From: Scala, Mary Joy
Sent: Monday, June 02, 2014 10:51 AM
To: Weatherford, Brenda
Subject: FW: 801 W Main

From: Darrell Bailey [<mailto:dbailey@bakerroofing.com>]
Sent: Monday, June 02, 2014 10:50 AM
To: Scala, Mary Joy
Subject: RE: 801 W Main

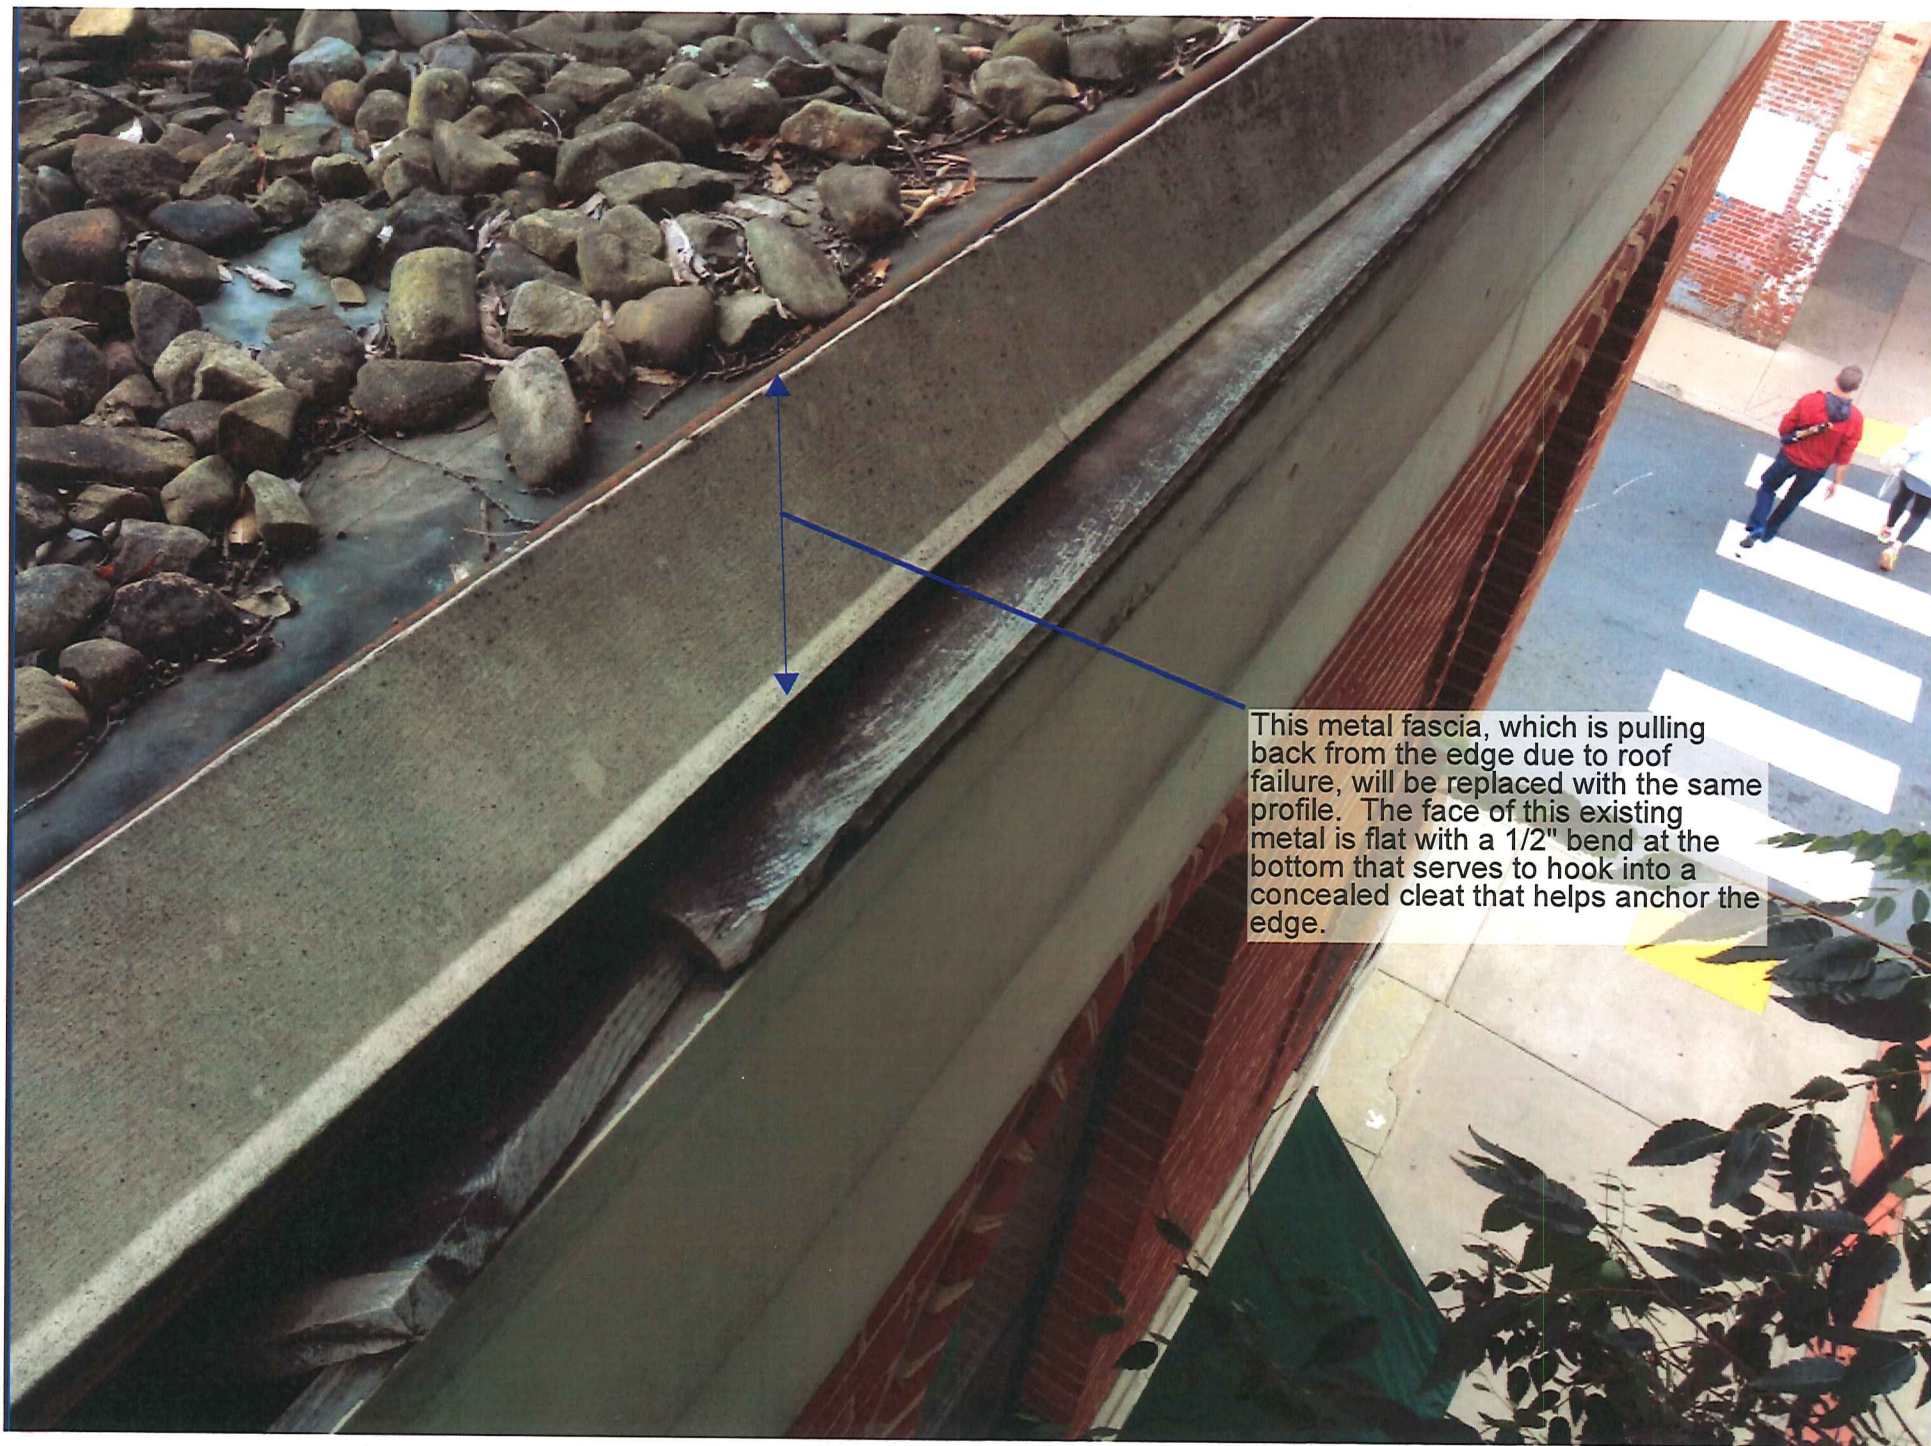
OK Thank you. I assume the new metal will be painted to match also.

This is the only visible element of the fascia / coping that will be changed. The new will be formed to match this.

This metal fascia, which is pulling back from the edge due to roof failure, will be replaced with the same profile. The face of this existing metal is flat with a 1/2" bend at the bottom that serves to hook into a concealed cleat that helps anchor the edge.

Yes, that is correct, we will work to closely match the existing. As with most paint matches to old construction, there will probably be some small visual difference due to having to match the old weathered fascia.
